**SERVICE BULLETIN**  
**NO:99010-r1**

MODELS : TX-DS575

SUBJECT : Noise is heard from "VOLUME MIN" to "VOLUME 1".

MODELS : TX-DS575

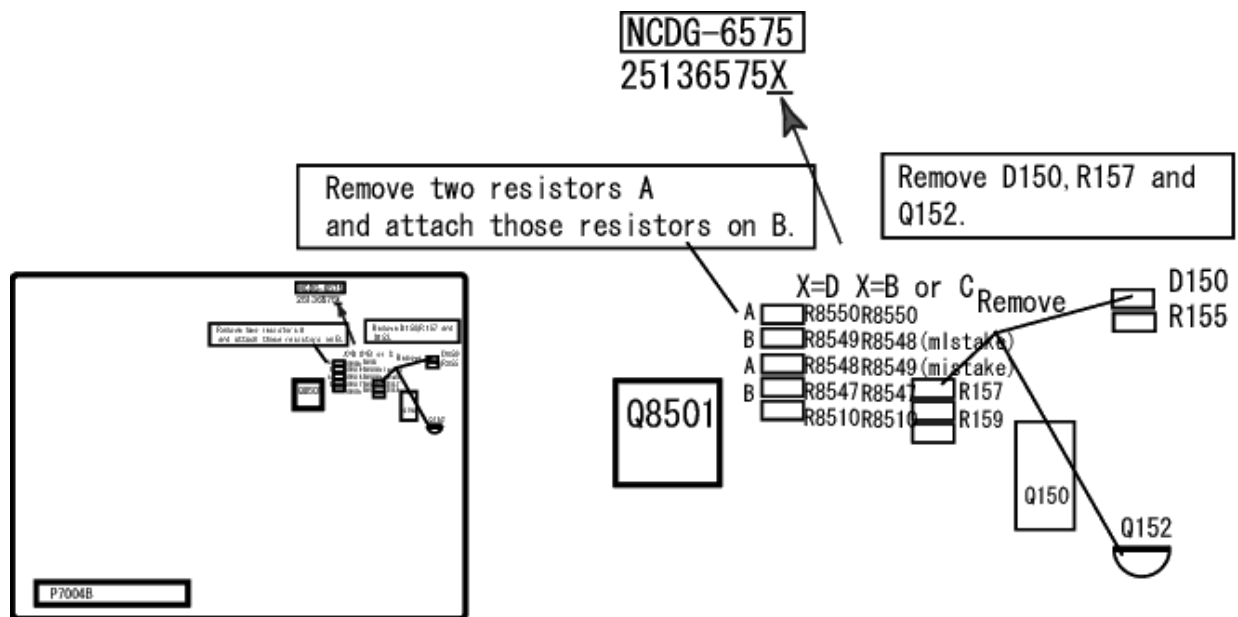
1. Microprocessor

This model is used the microprocessor of 3 types.

When replace the microprocessor Q7001, refer to the remarks below.

Note: When you change the microprocessor from 045-3BA to 047-3BA, remove 2nd PLL circuit and change the setting of A/D,D/A Converter IC Q8501.

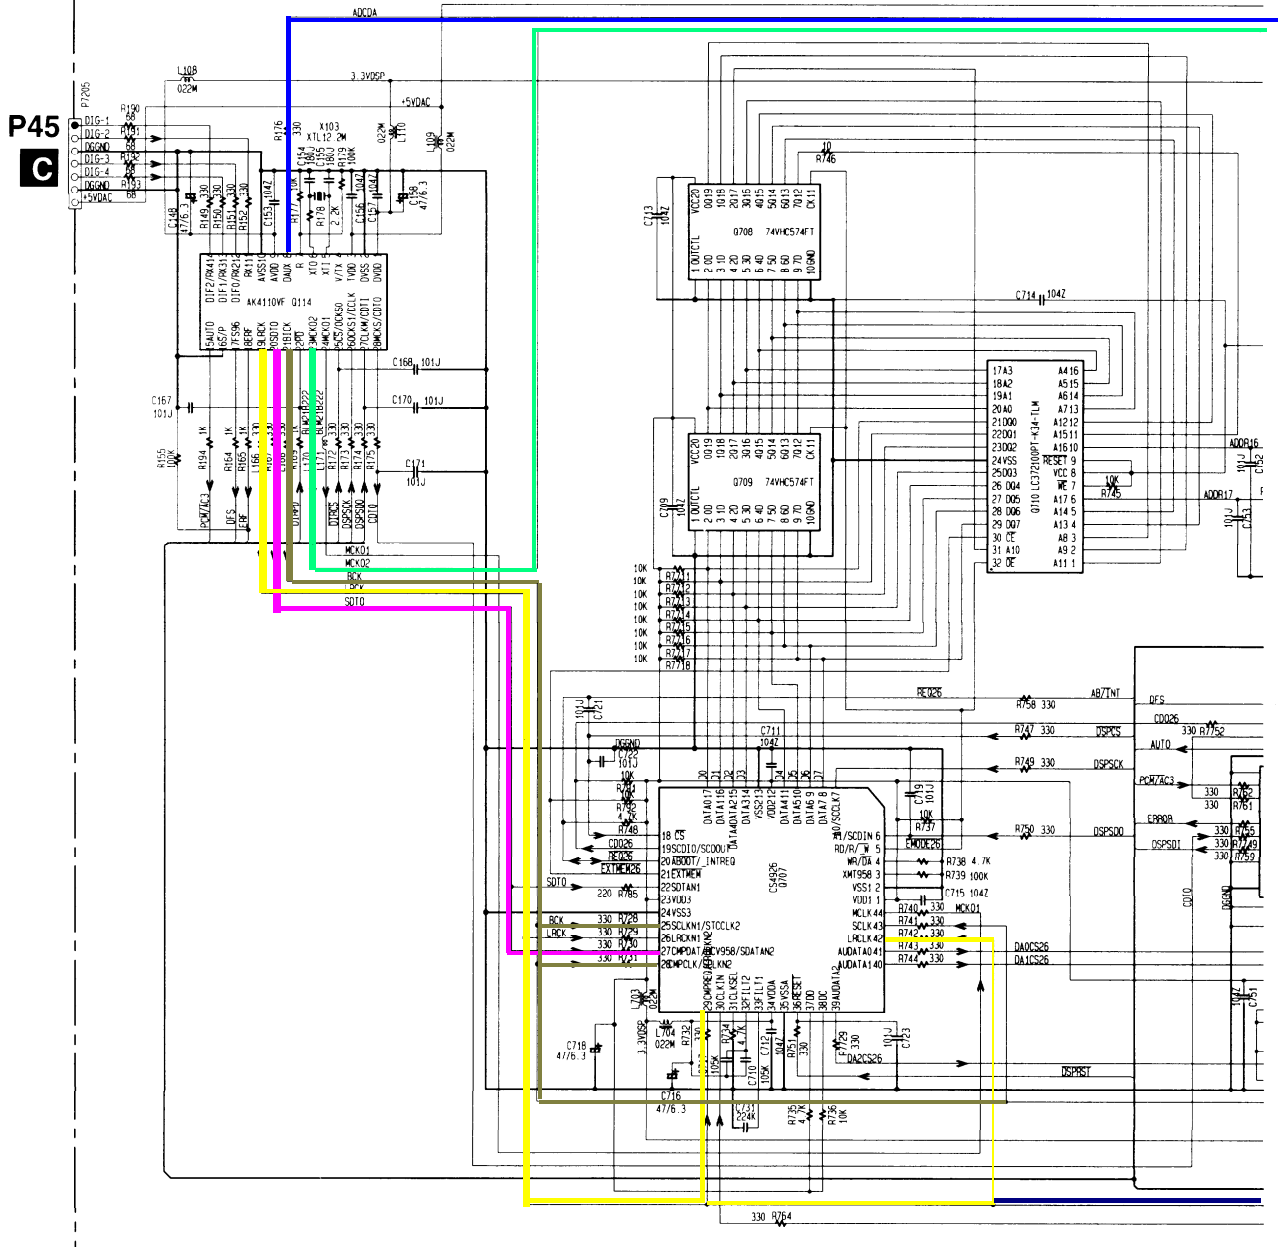
Audio Data from Q8501 Pin 9 arrives at Pin 8 of Q114.

Same data will find its way out at pin 20 of Q114.

It is important X0-XI Pin 5, and Pin 6 work correct and that 12.2Mhz oscillation is present. No noticable drift or Jitter should be noticed.

Analog Digital

Q114 Pin 15 = L → =H

Q114 Pin 17 = H → =L

Q114 waveforms when input is analog.

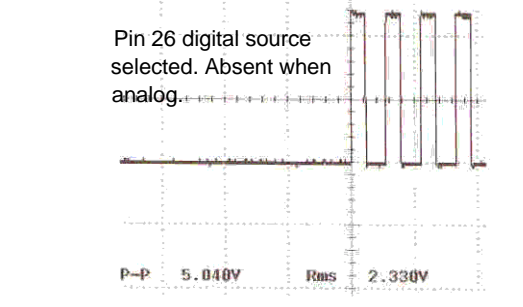
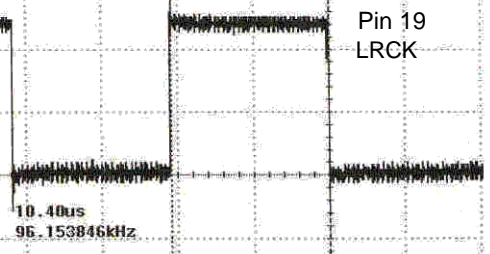
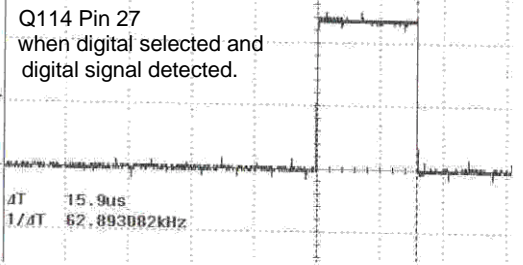
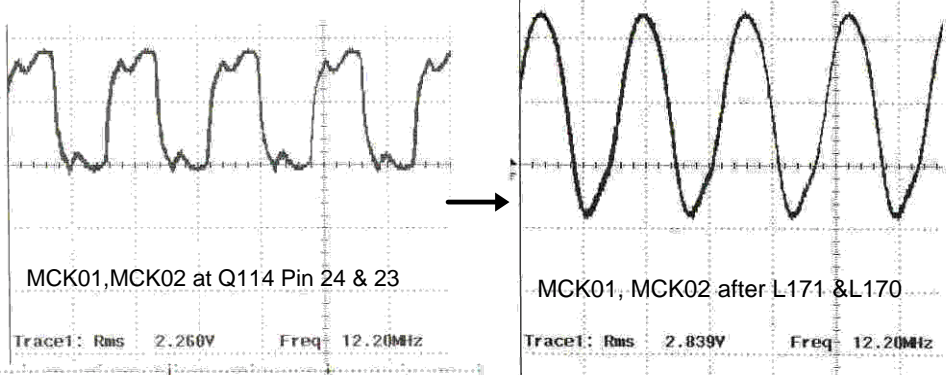
It is conditional that audio data is present at Pin 8 (DAUX) of Q114 and that X-tal X103 is ON in-order for Q114 to operate properly. The digital condition set forth at Pin 15 and 17 along a presence of digital data at Pin 13, 12 and 11 will turn OFF X103.

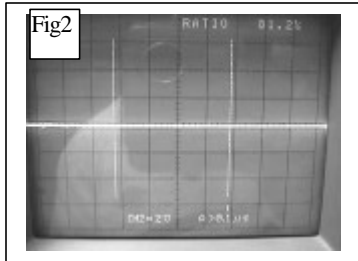
Pin 12 data is OK

Fig2: Pin 26 and 27 clock is OFF when digital signal is present at pin 12.  
Pin 15 has no signal.

**Q707** (problem begins to show at:)

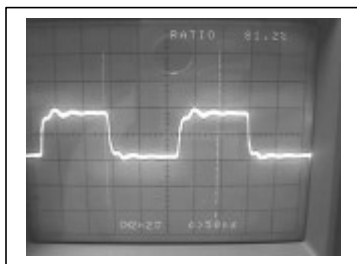
Pin 39 and 41 has no data.

Pin 30 appears this way.

## Pin 29

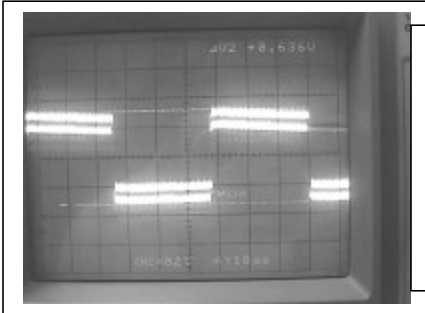
Pin 41 has a problem as seen. This point is normally 4.5vpp rather than .636vpp. The data appears to be corrupted or very low. If the unit is working properly this point becomes very high and clear data is present. At the same time when the unit appears to work, Q707 temperature runs warmer than when it is not.

At this point a re-check of pin 8 through 17 revealed that some of the data line DC voltages were not as they should be. See chart.

Q710 Defective. Replaced and unit worked.
